Hearing Date:	Tuesday 21 and Wednesday 22 August 2018
To:	Hearings Commissioner Rob van Voorthuysen, appointed by Napier City Council
S42A Officer:	Shane Lambert, Senior Resource Consents Planner, Napier City Council
Applicant:	Bupa New Zealand
Regarding:	Commissioners questions issued 30 July 2018
Date:	15 August 2018

COMMISSIONERS QUESTIONS

NCC s42A Response to Commissioner Questions RM170155

Figure 1. NCC GIS image.

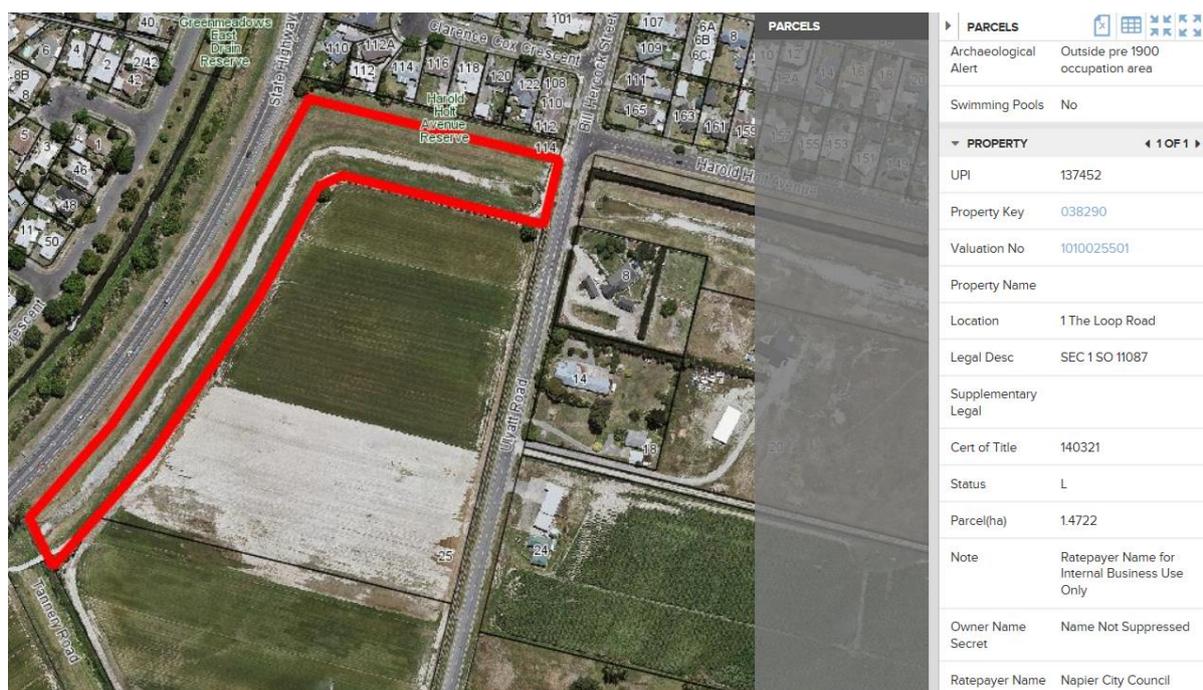
Who owns the reserve between the Cross Country Drain and the applicant's site?

10. Napier City Council owns the land upon which the Cross Country Drain (also known as the Purimu Drain) follows. Which is the land adjoining the subject site, and all the land on which this drain follows leading to the pump station at 283 Te Awa Avenue. This includes the land between the site and the physical drain. Attachment 1 is the land title (Computer Freehold Register 140321) and SO plan (SO11087) confirming the ownership and drainage purposes.
11. See also the below aerial image/information taken from NCC GIS (figure 1):
